LEESTON PLAN CHANGE - RFI RESPONSE

Thank you for your letter dated 19 September requesting further information regarding Plan Change PC190062: Private Plan Change Leeston. Baseline Group has prepared the following response.

Leeston Plan Change

NW Leeston - 200 year flood model results

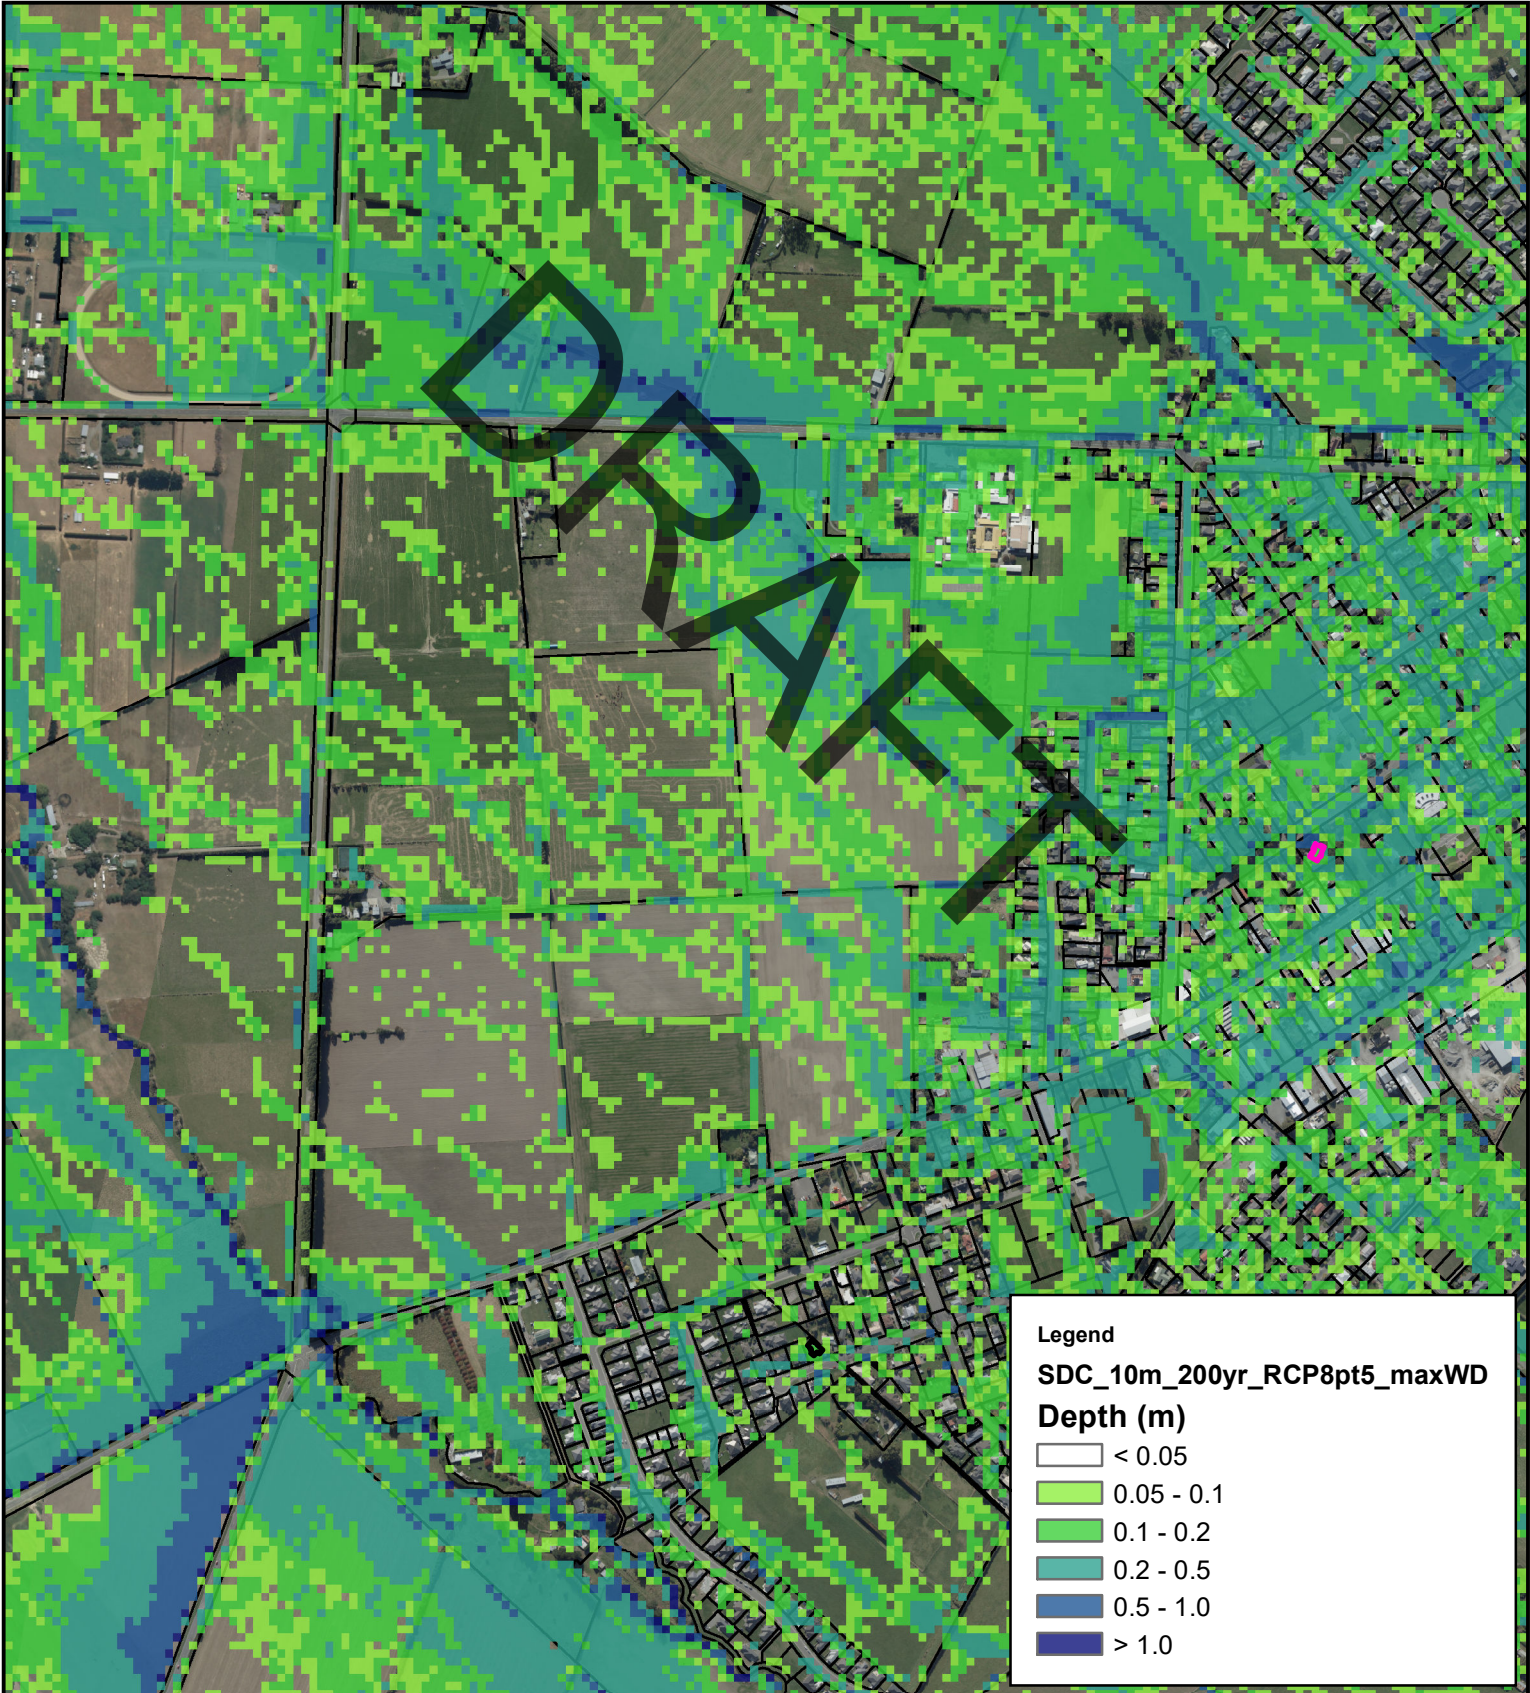
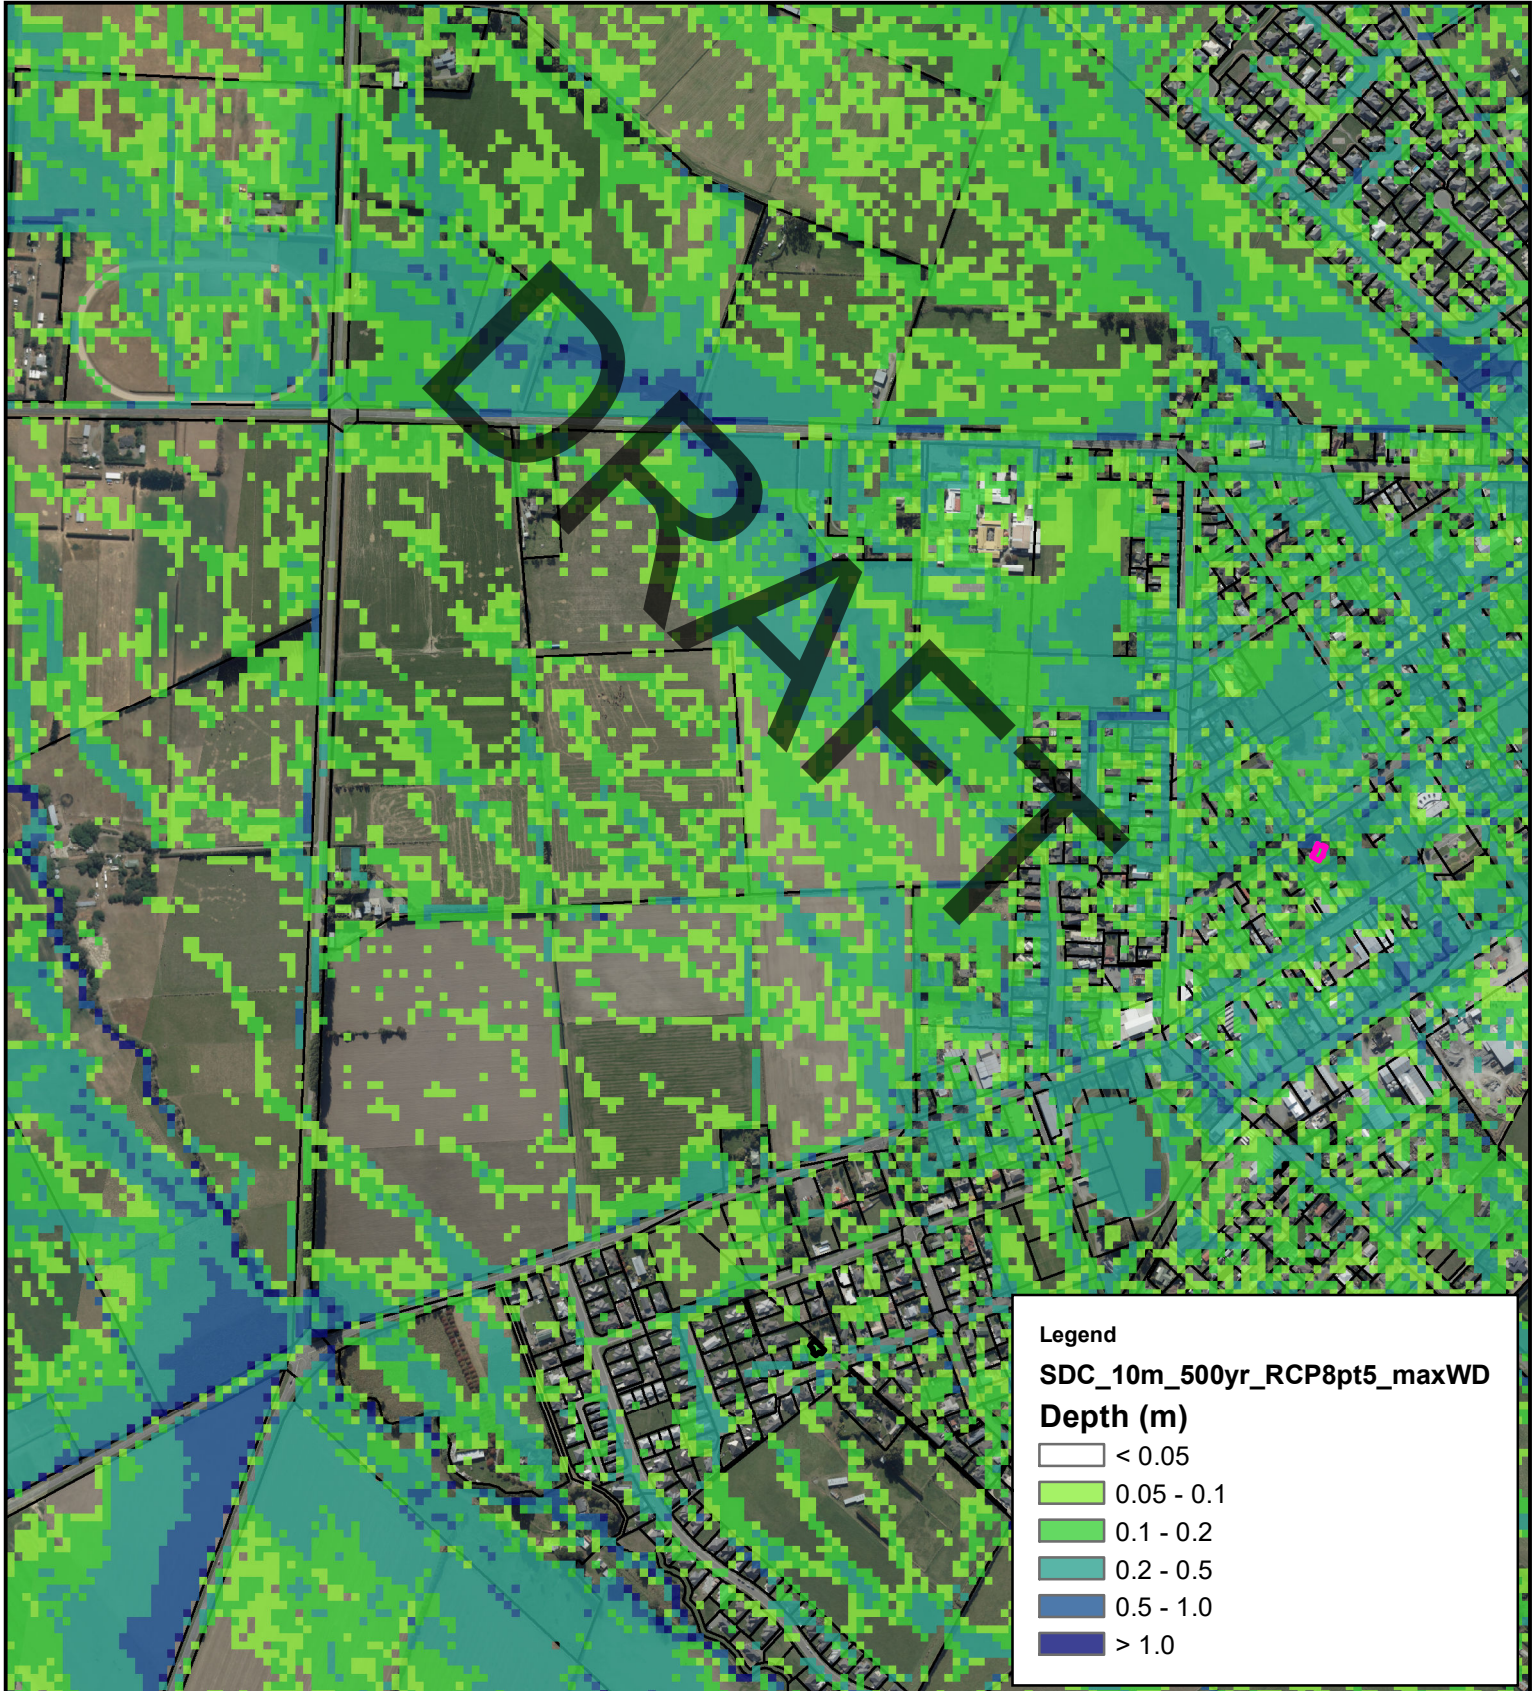
4. *Please confirm that the 2015 LiDAR data provided in Appendix 6 is the latest data available, and that the balance of the advice from Environment Canterbury in 2017 is still current.*

ECan have confirmed the 2015 LiDAR data is the most up to date. Email confirmation is attached to this letter in Appendix 1. In addition, ECan have provided the draft results from flood modelling of the 200 and 500 year return period (0.5 and 0.25% AEP), which are also attached in Appendix 1. Note these are draft versions and final results of the modelling have not been released.

The results of the draft modelling show parts of the plan change site being subject to surface flooding and provides evidence of specific areas within the plan change site that are more susceptible to flooding and ponding. This information is helpful to Council and any future developer of the site as it shows the areas that are not affected by the 200 year flood event which could be developed first and before the stormwater bypass is constructed. It shows there are areas in the plan change site that could be developed and would not be subject to inundation in flood events.

As discussed on the phone, the 2015 LiDAR is the most up to date LiDAR

I have attached two maps showing flood depths for a modelled 200 and 500 year return period district wide rainfall runoff event.

Figure 1: 2019 Peak Hour Traffic Volumes at Market Street / High Street Intersection

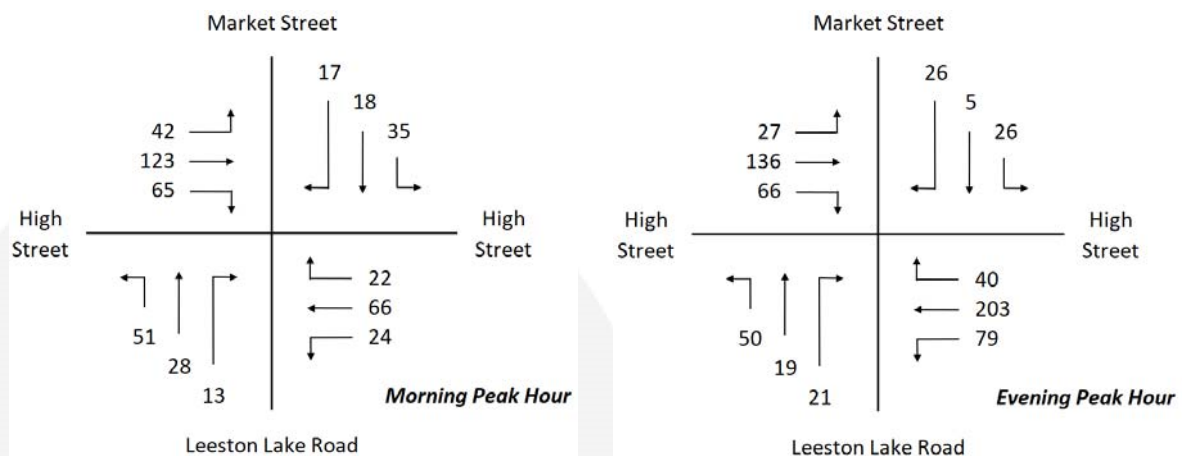
9. *The Transportation Assessment does not provide a level of service assessment of the Market Street/High Street intersection resulting from the likely increase in traffic from the west (and likely north from Leeston Dunsandel Road) as a result of the proposed plan change. There are presently concerns within the community regarding the existing level of traffic using this intersection. Therefore, given that the Transportation Assessment indicates that there will be a significant increase traffic volumes east along High Street, the assessment needs to be extended to cover the Market Street/High Street intersection and any issues identified need to be addressed, to allay or mitigate these issues.*

To determine the existing traffic volumes, we surveyed the intersection during October 2019, and the results are shown below.

The results show low queues and delays. This aligns with our initial assessment, and also our observations on site during the surveys.

Figure 2: Traffic Generation from Plan Change Area onto Feredays Road (No Spring Place Access)

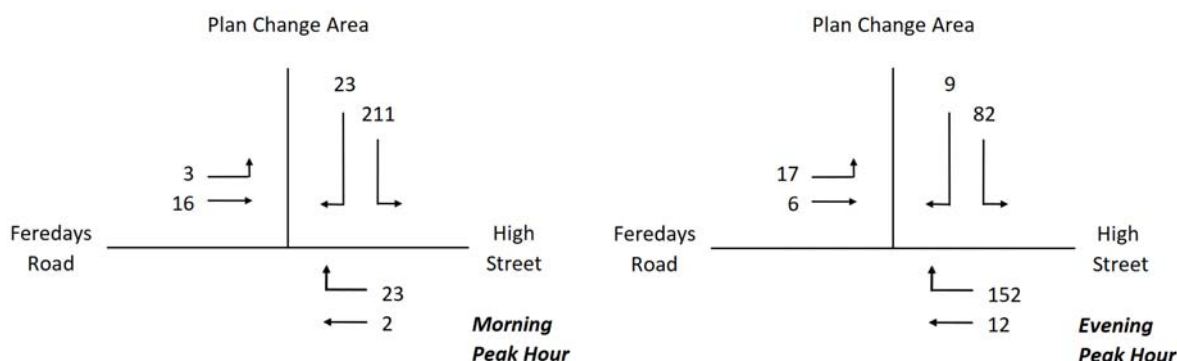
The RFI queries the contingency plan if the connection through to Spring Place cannot be formed.

Allowing for the traffic flows on Feredays Road (as set out in Section 4.1.2 of the Transportation Assessment), this leads to the following intersection performance (assuming a priority intersection):

The intersection provides an excellent level of service with low queues and delays, even under the expected traffic loading. In the event that the intersection was to be a roundabout (as we understand has been suggested), queues and delays would remain similarly small.

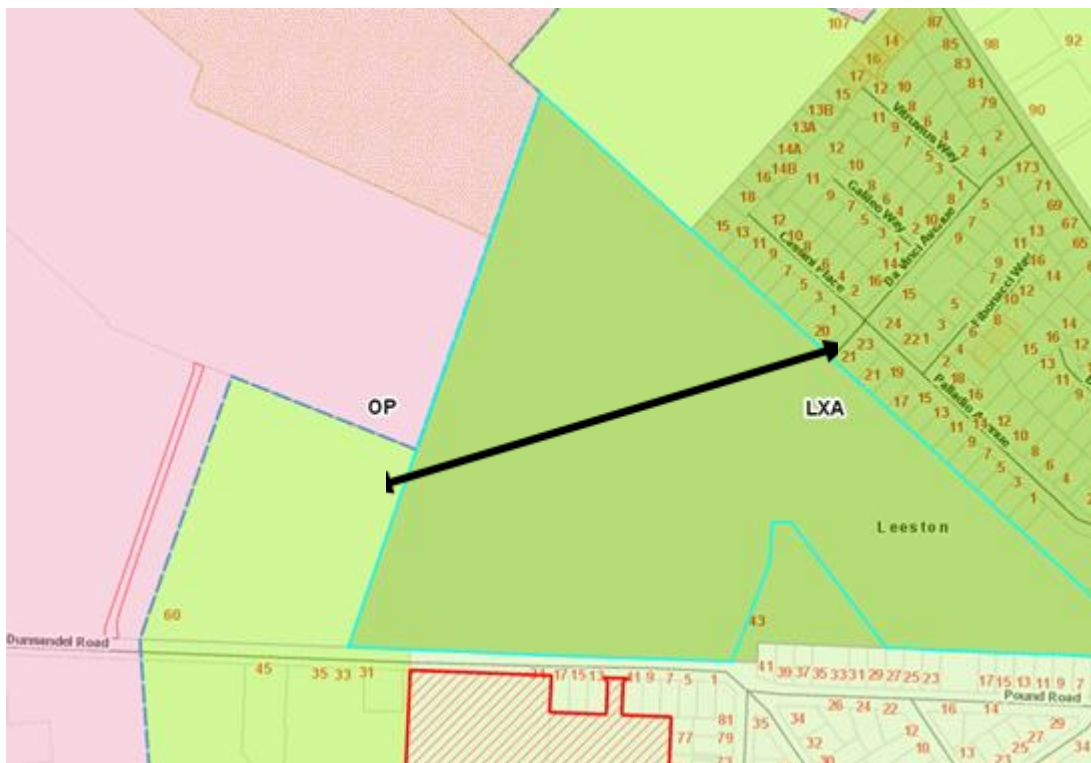
11. While a future roading connection is shown from the northern part of the site to the east, into the adjoining land known as the 'Martin Block', the approved plan of subdivision for the 'Martin Block' does not appear to allow for this. Similarly, the indicative plan of subdivision included in the Transportation Assessment also does not appear to provide for this. As such, access to the northern block would likely operate as a cul de sac, the overall length of which is inconsistent with the provisions of the operative district plan. Please provide an alternative road layout for the northern portion of the site that would increase the resilience of the network, should one access be blocked for any reason.

I can confirm that the subdivision consent over the land known as the Martin Block has lapsed and therefore there is no valid consent over this land.

The request for further information dated 19 September 2019 requested that the transport network be reviewed in relation to the northern block, to increase the resilience of the network. Flexibility now exists to allow for a connection to the east, such that the northern block of the proposed plan change area provides for an opportunity to link through this area, over the Martin Block to Da Vinci Avenue further east, as shown below.
